**SUBJECT:** Addendum No. 4

**REFERENCE:** Invitation To Bid (ITB) for IAH Terminal D Conveyance Replacement at George Bush Intercontinental Airport (IAH), Solicitation No. HOA-CONREP-2024-015; Project No.1028

**1 MOVING WALKWAY DMSW-1**  
SCALE: 1/8" = 1'-0"

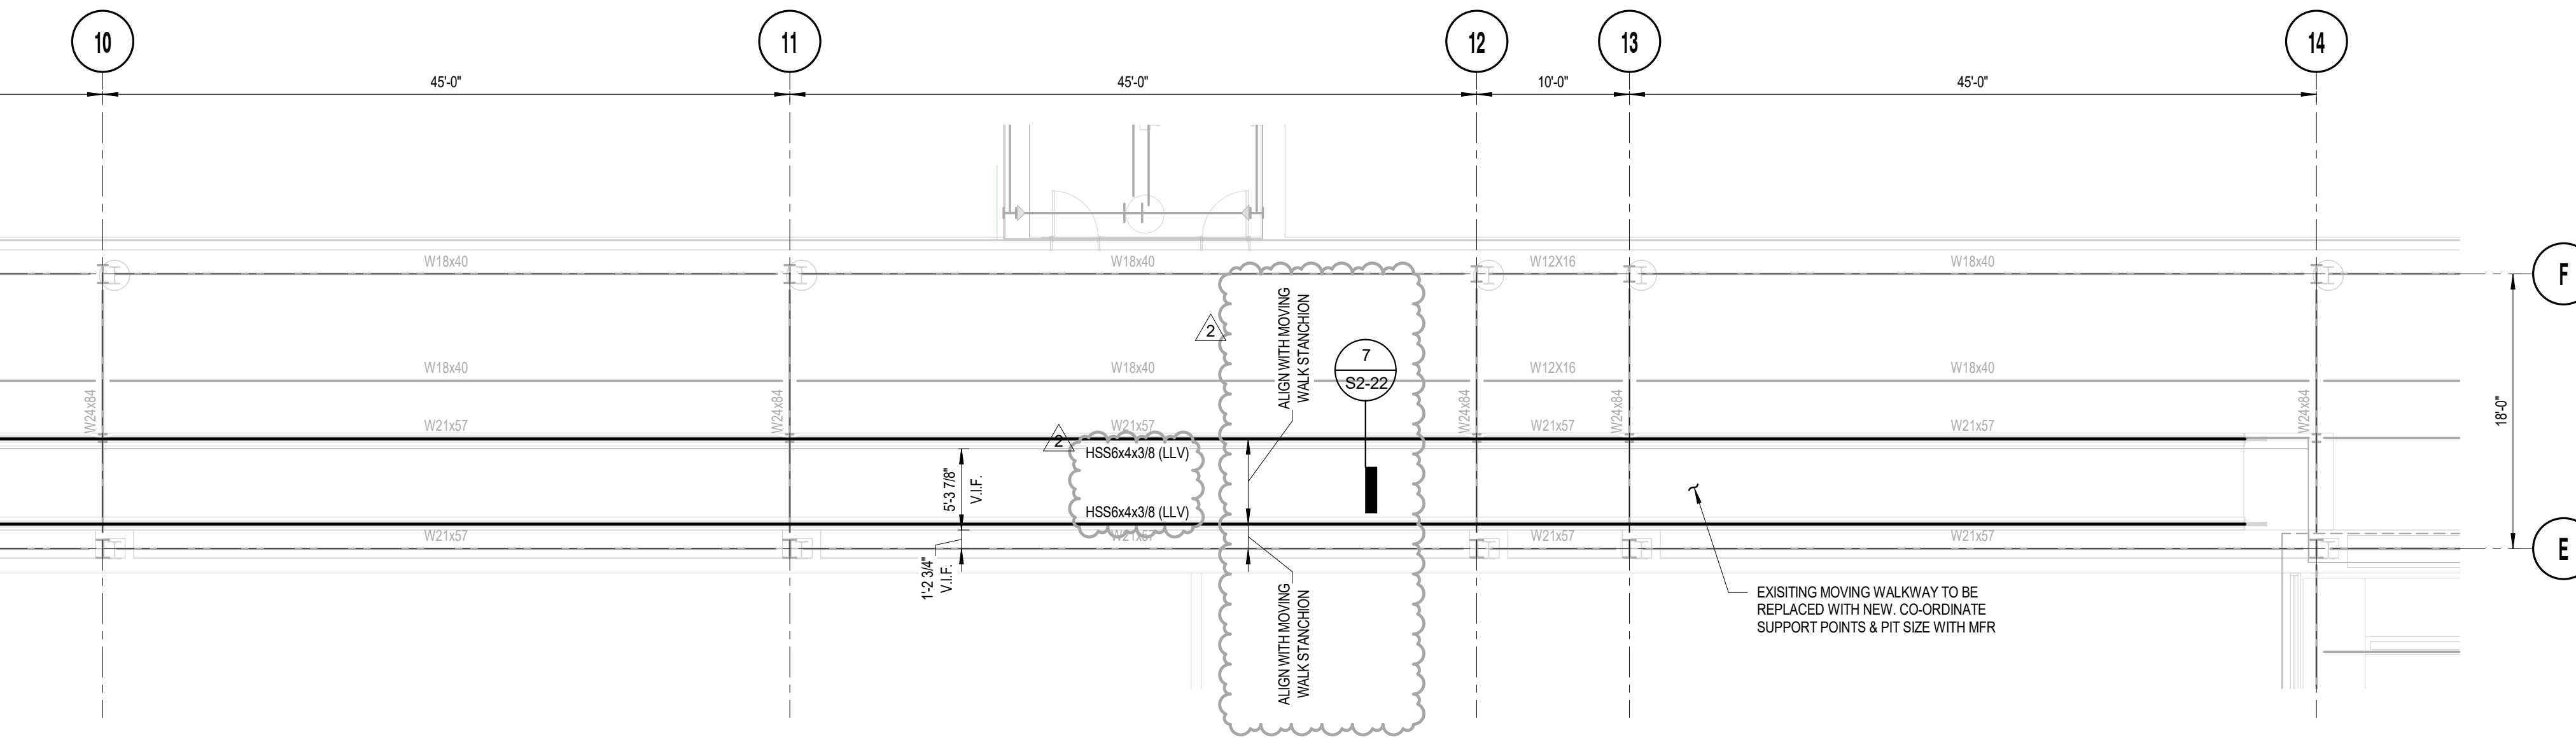
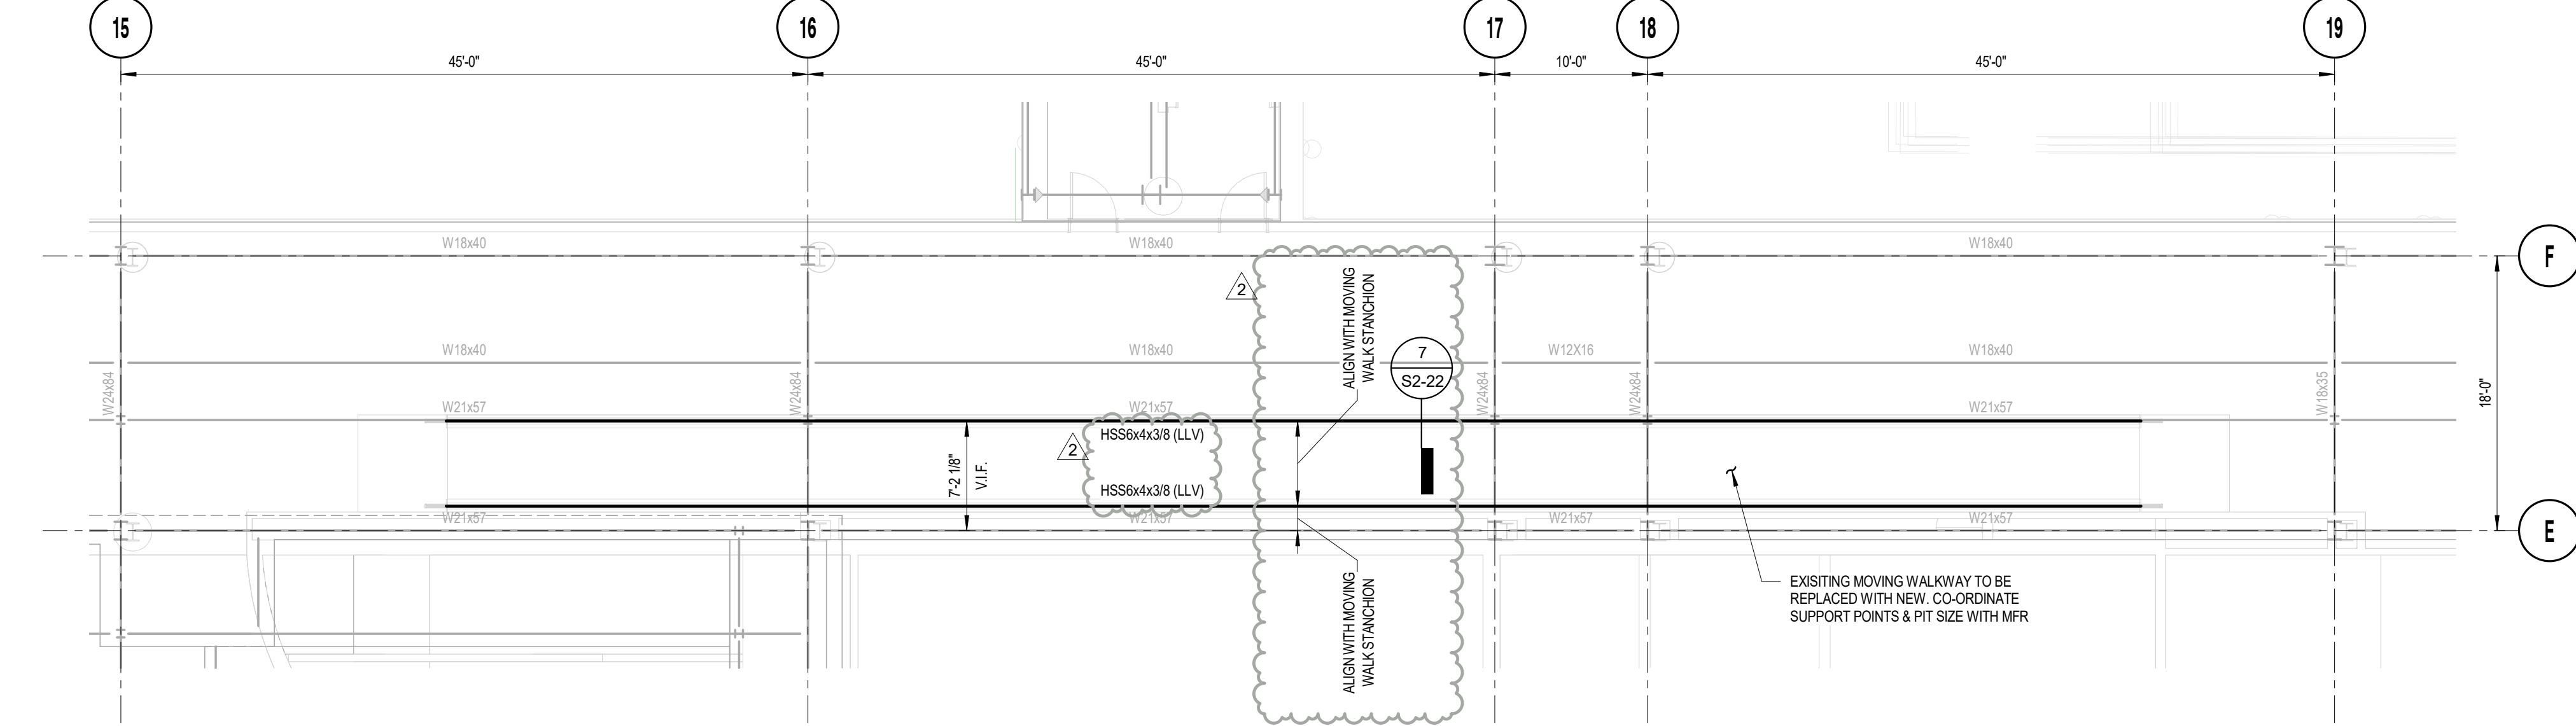
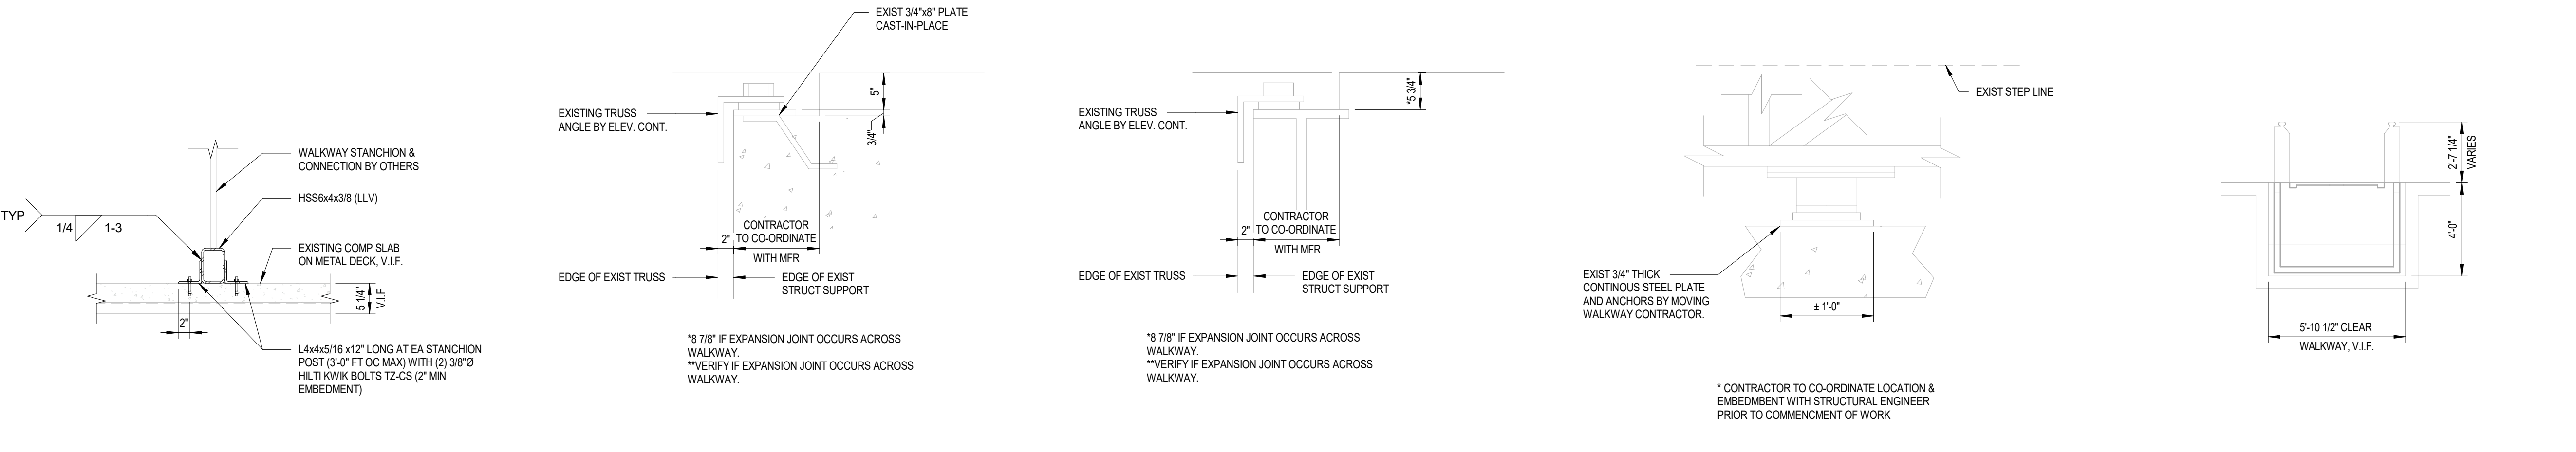
38. **Question:** Walks DMSW 1, 2, and 3 – please confirm we can anticipate bringing all material in through the window removal location shown in detail two on A2-02. This is approximately 200 feet from the end of walk #3 and approximately 1300 feet from the center of walks 1 and 2. This will be problematic based on the amount of material that will need to be removed and brought in, so please advise if there is a better alternative than what was not discussed at the walk-through.

**Response:** Please refer to the response provided in Question #35.

**1 MOVING WALKWAY DMSW-4-7**  
SCALE: 1/8" = 1'-0"

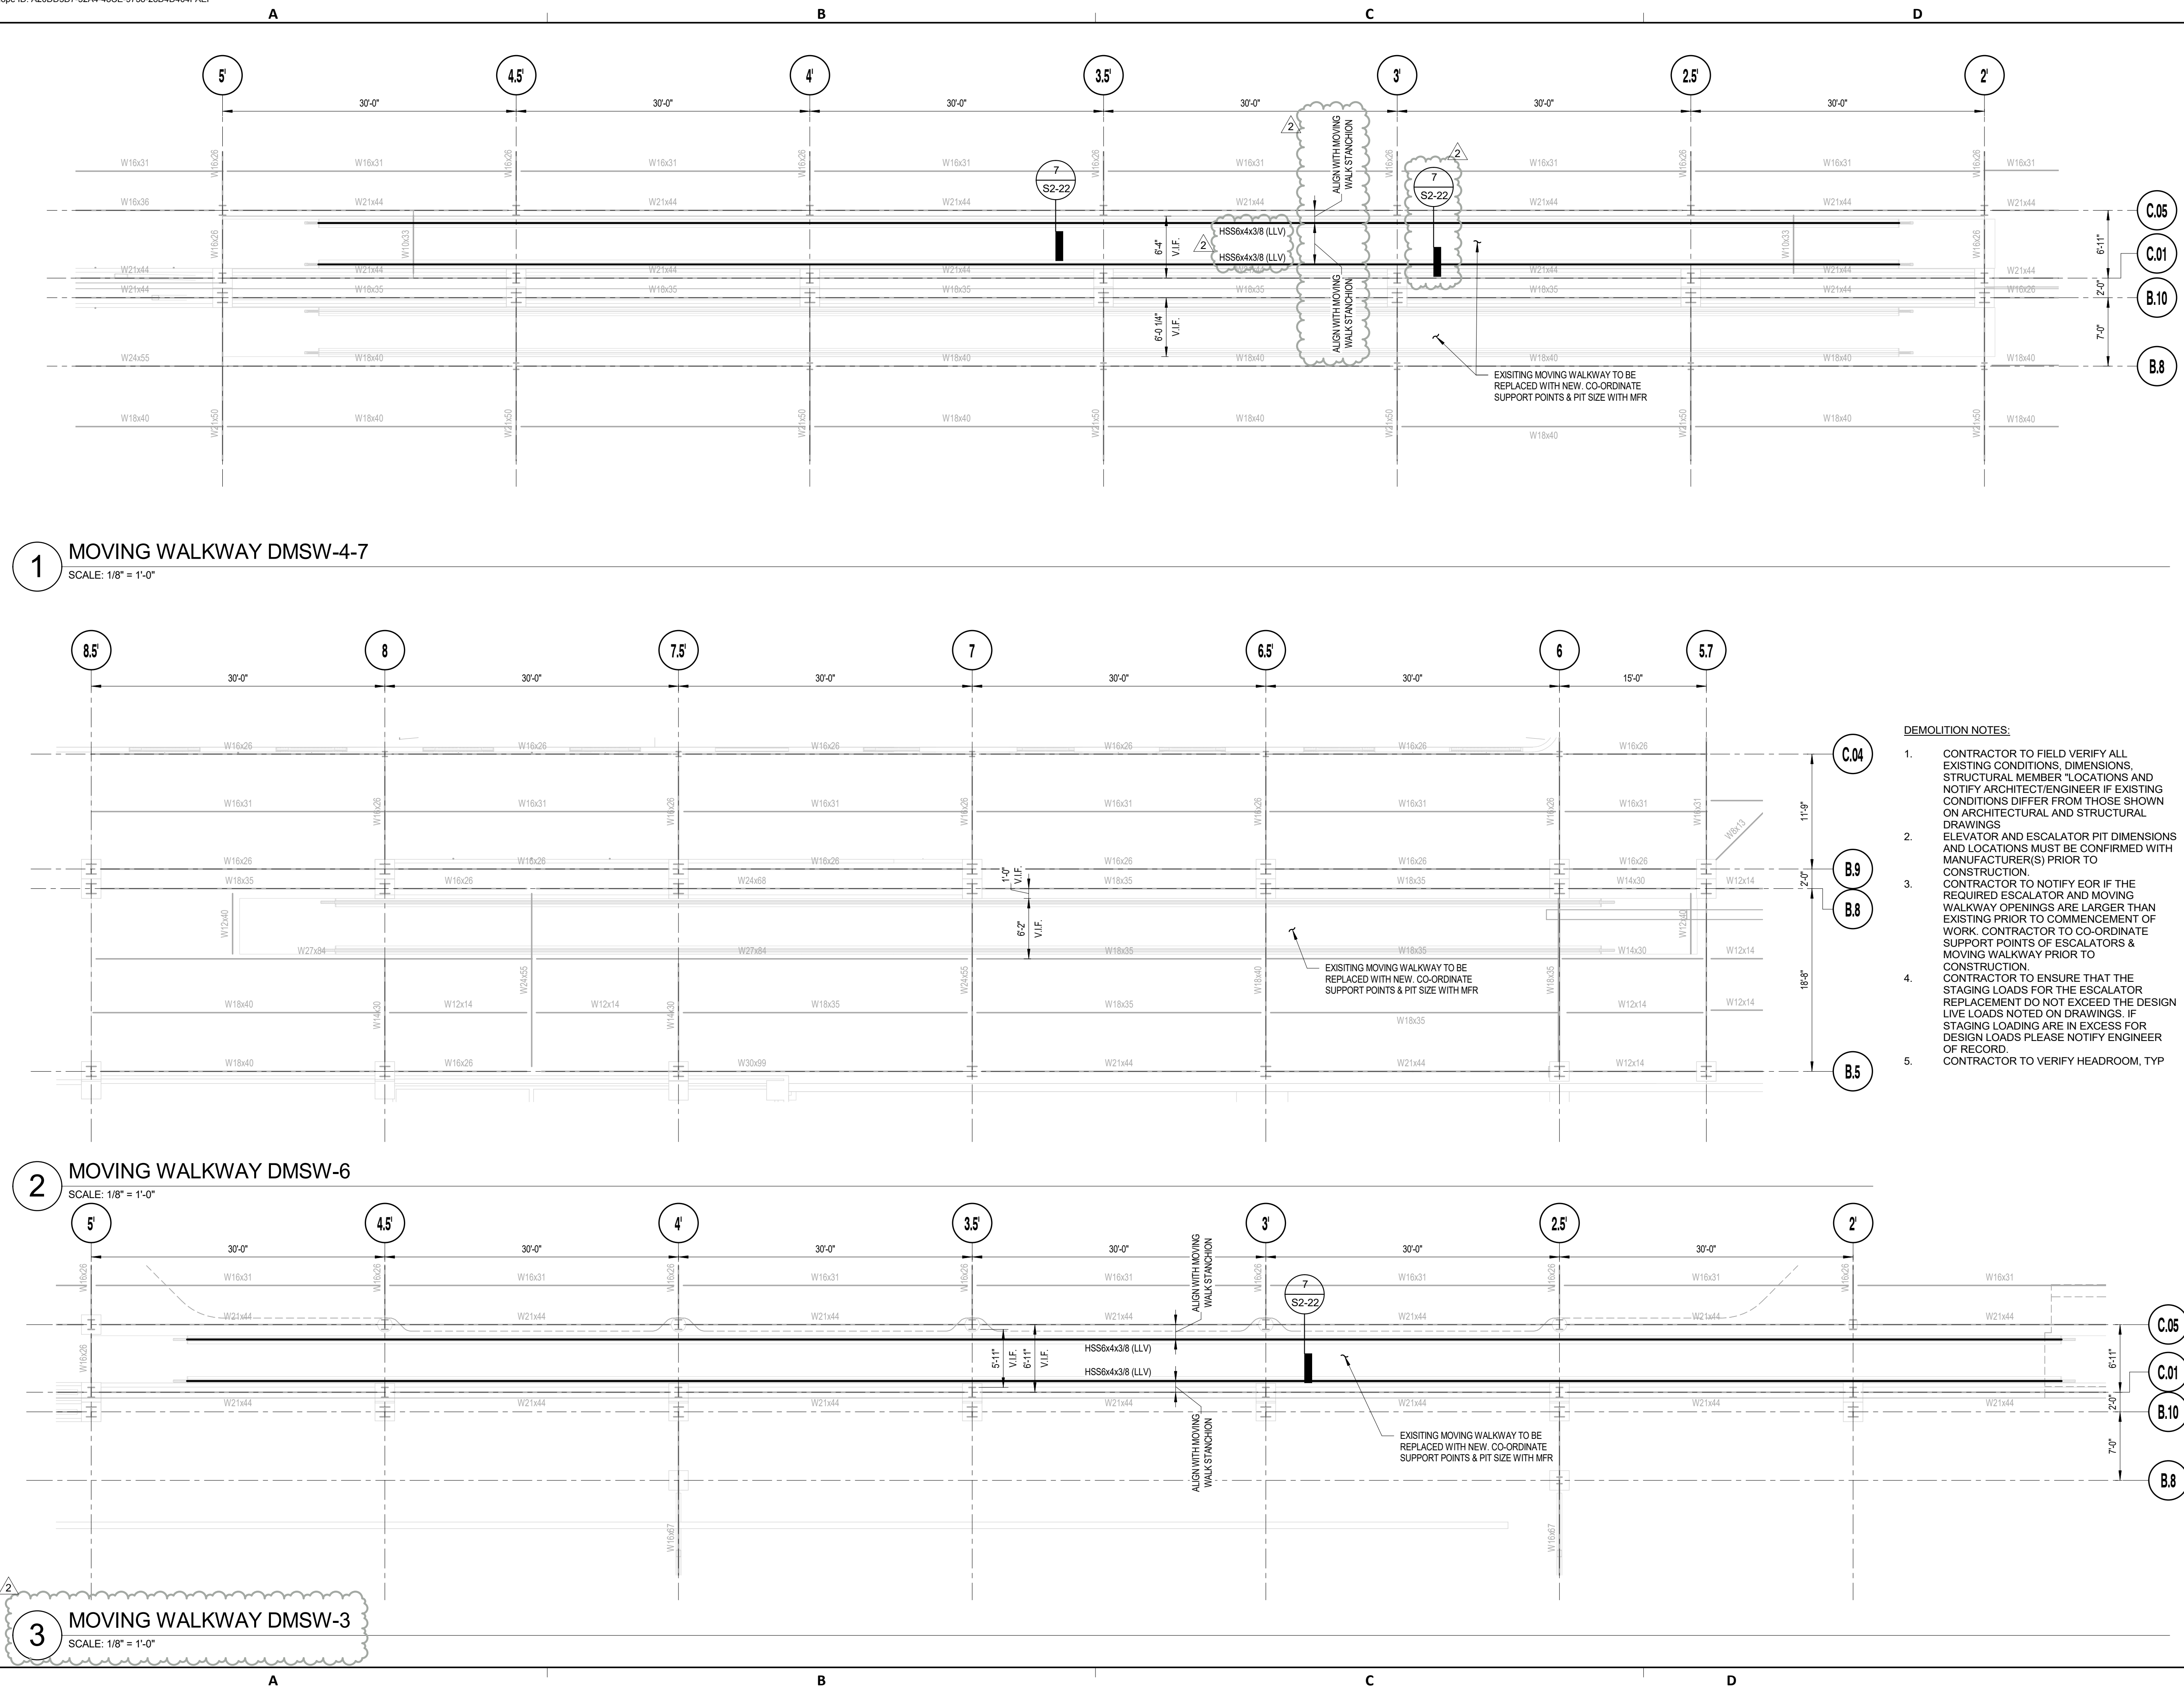
31. **Question:** Elevators: The drawings (A3-04) show a large storage area adjacent to walk DMSW-4. Please confirm that this storage space will be available for the duration of the project.

**Response:** No issue between the unit and the north wall, using floor-to-ceiling dust wall.
